## Product Change Notification

**BU-018568-SL**

**Issue Date : 23 August 2019**

Affects part numbers: FX0462

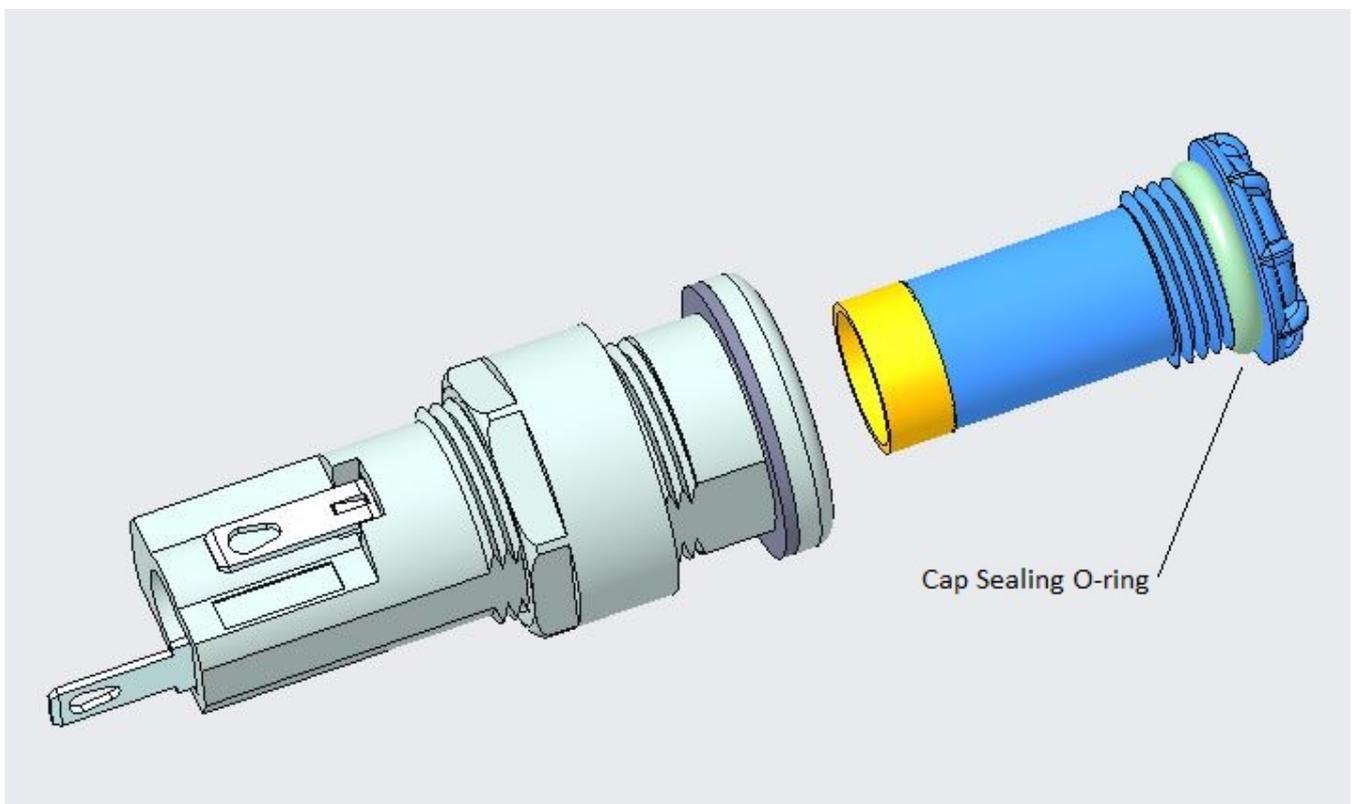
Due to our ongoing product improvement and reliability program, it is now proposed to up issue FX0462 in line with this. These changes include a change of o-ring as detailed below. Up issuing the current part number and not creating a new part number means that this will also eliminate the requirement for our customers to update their approval files and associated costs.

### **Current O-ring**

Dimensions – ID 7.65mm, Section 1.63mm, 70 shore Nitrile.

### **New O-ring**

Dimensions – ID 7.66mm, Section 1.78mm, 70 shore Silicon.
